METROPOLITAN GOVERNMENT OF NASHVILLE AND DAVIDSON COUNTY

STAFF RECOMMENDATION
1222 7th Avenue North
April 17, 2013

Application: New construction-addition
District: Germantown Historic Preservation Zoning Overlay
Council District: 19
Map and Parcel Number: 08209025900
Applicant: Jack Link, Owner; James Johnson, Contractor
Project Lead: Sean Alexander, sean.alexander@nashville.gov

ROOF PLAN

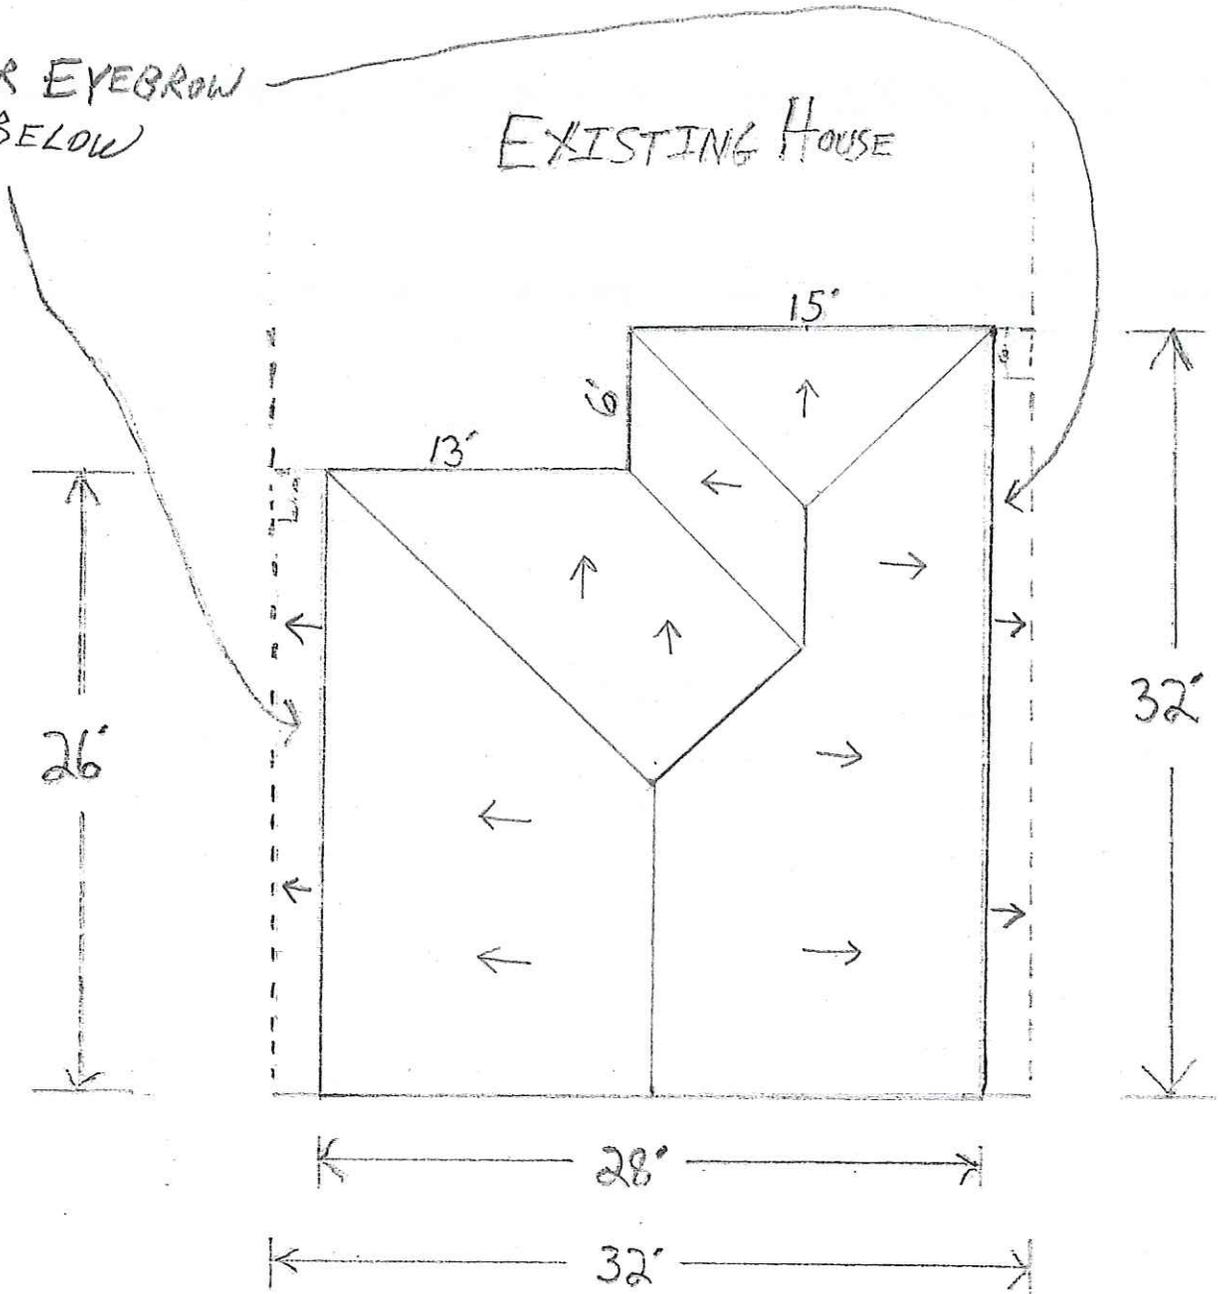
The roof of the addition will be a 3:12 pitched hip, with a gable facing the rear. This pitch is significantly lower than that of historic house, which is 12:12. Although a lower pitch is not always appropriate, in this circumstance it helps to reduce the height and visibility of the addition overall. The house has two brick chimneys that will be rebuilt, reusing the existing brick. Staff finds this to meet guideline 2.7.

The location of the HVAC and other exterior utilities is not indicated on the site plan. Staff will need to approve their location, if they are moving. There is an existing concrete walkway on the front and left side of the house, which will not be removed. There is a chain-link fence on the sides and rear of the property, for which no change has been indicated. The only new appurtenance shown is a new paved parking area at the rear of the property that is accessed from the alley. Staff finds the retention of existing appurtenances and the new paved parking at the rear of the lot to be appropriate and to meet Guideline 2.8. New appurtenances or relocation of existing appurtenances should be approved by MHZC staff.

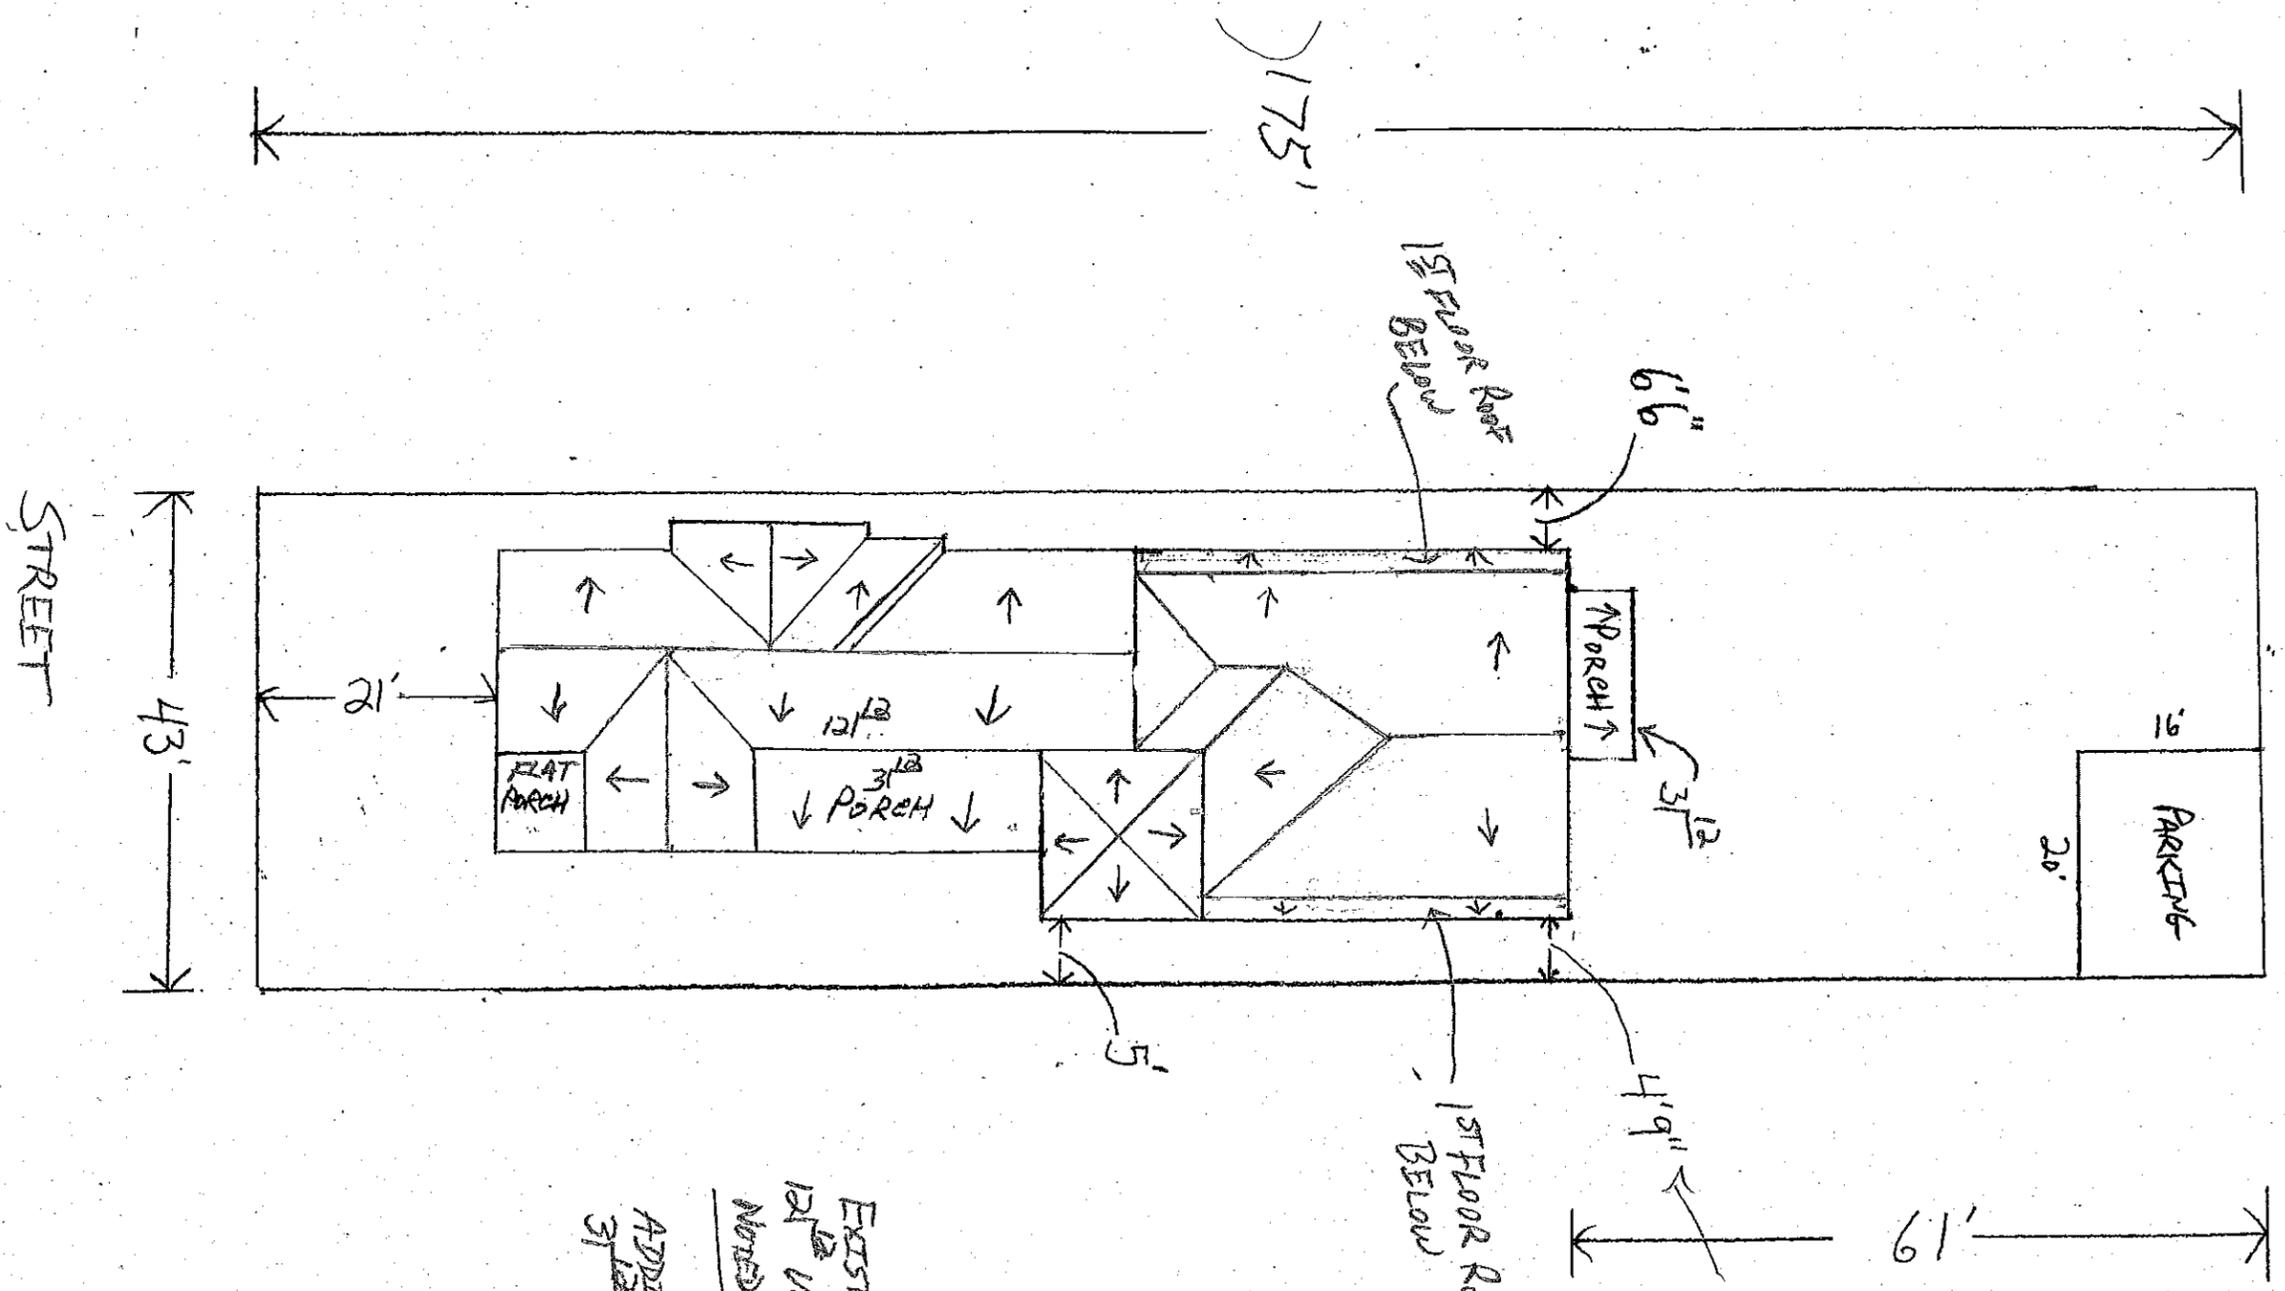
The side walls of the new addition will step in from the sides of the existing building by one foot (1'), carry back to the rear two feet (2'), and then step back flush with the walls of the house. The addition will increase the depth of the house thirty-two feet (32'), just over half the depth of the existing house.

The addition will match the orientation of the existing house, will maintain the rhythm of spacing between buildings, and will meet or exceed the three foot (3') minimum setback required by the MUN base zoning.

LEFT ELEVATION

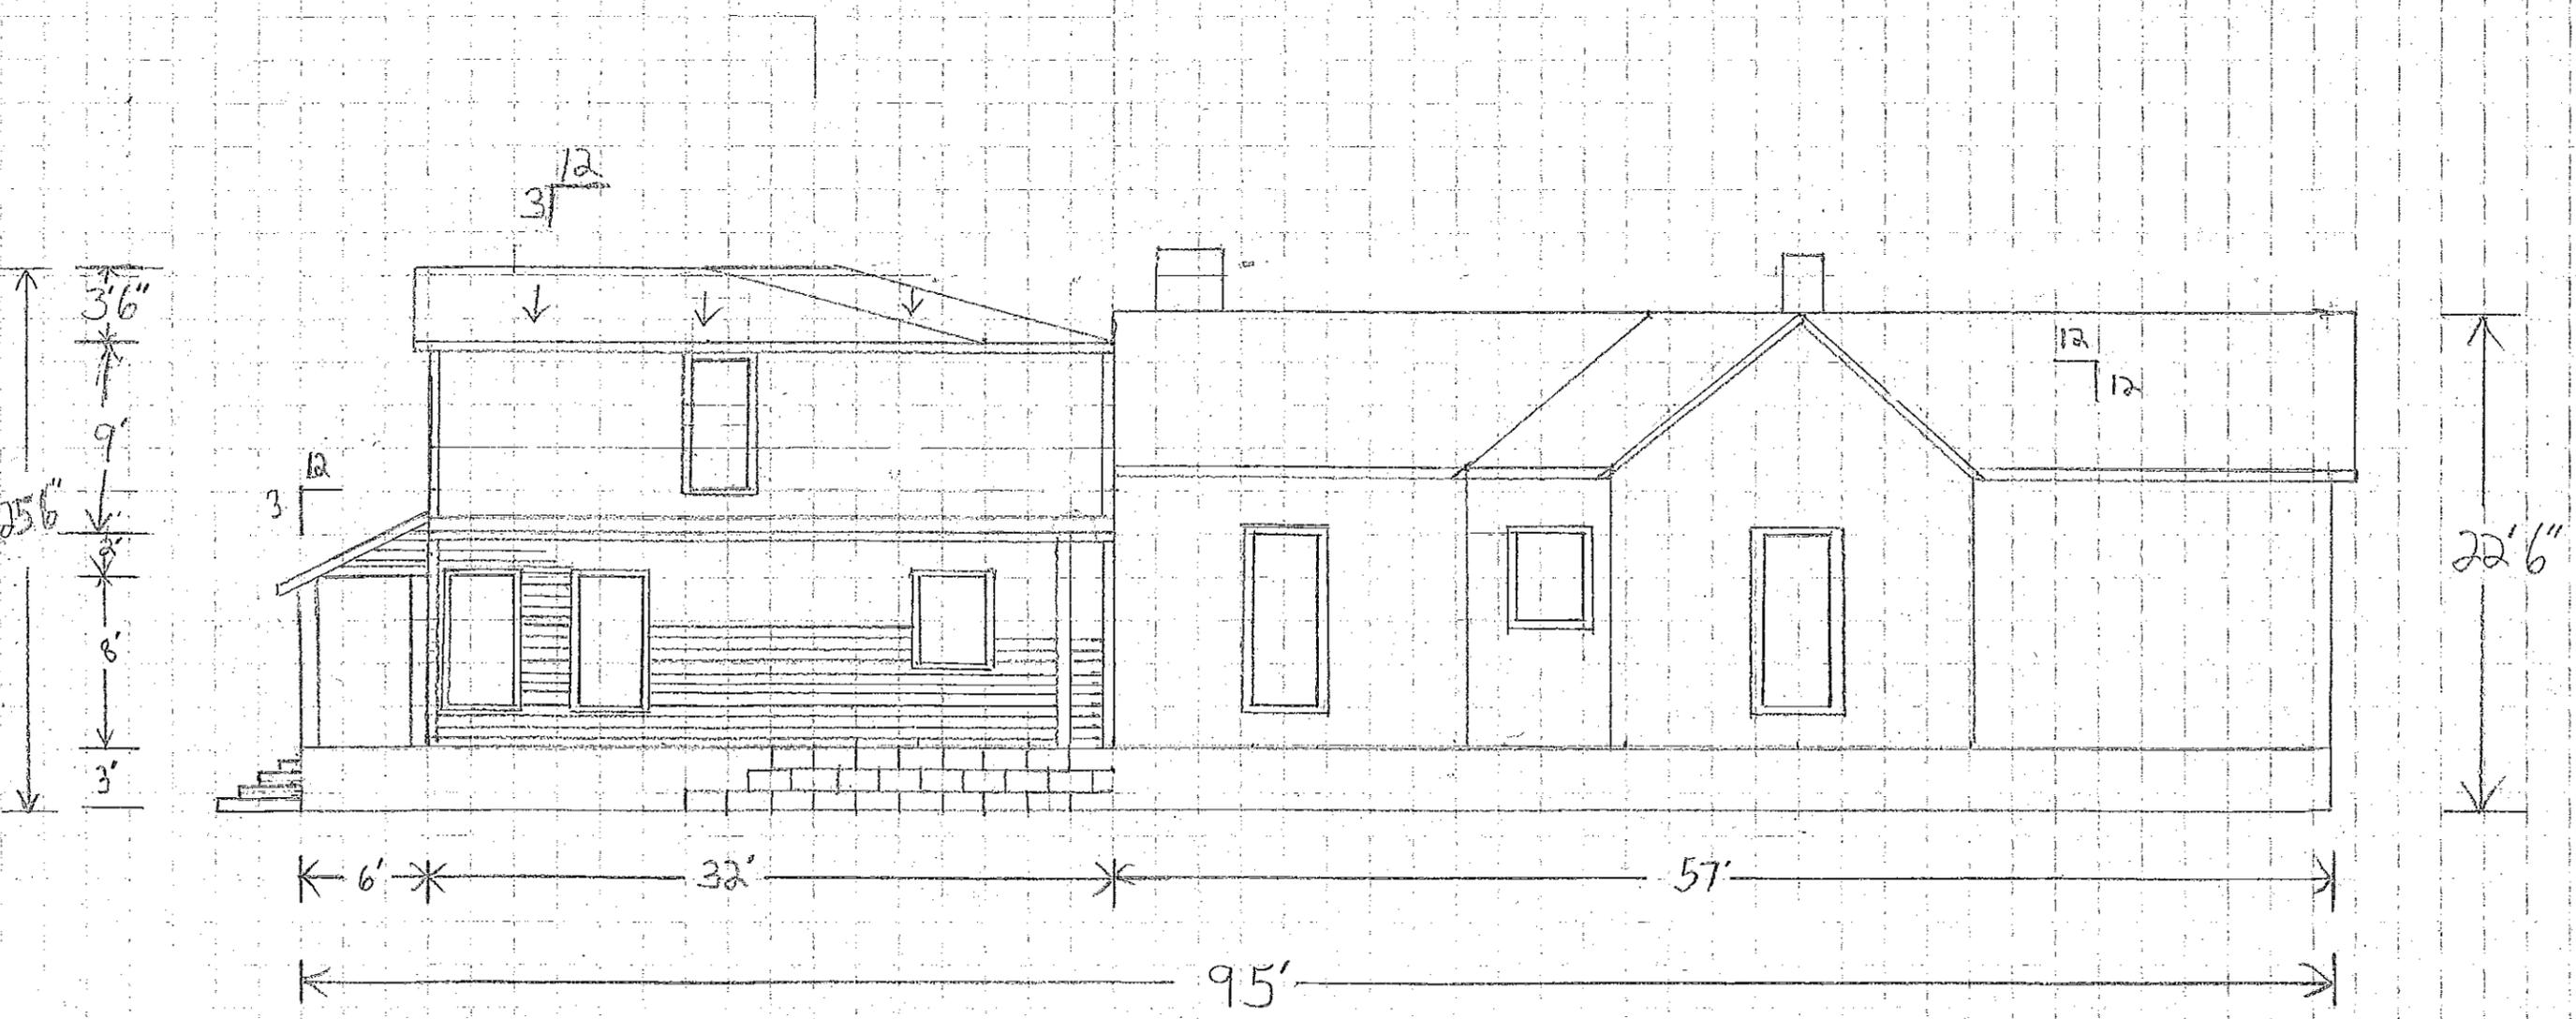
The addition will be two stories tall, whereas the existing house is only one story. However, by reducing the ceiling heights in the addition the new roof will only be three-feet, six inches (3'-6") taller than the existing roof. The upperstory walls will step in an additional one foot (1') from the sides of the wall below, with an "eyebrow eave" or pent-roof at the transition between floors. Staff finds this added height is appropriate because it sets in sufficiently from the sides of the house, is entirely behind the mass of the historic house, and will not have a substantial impact on the historic house form.

1. the rear porch columns have bases and capitals;
2. staff review and approve the foundation material, window selections, and any new or relocated appurtenances;
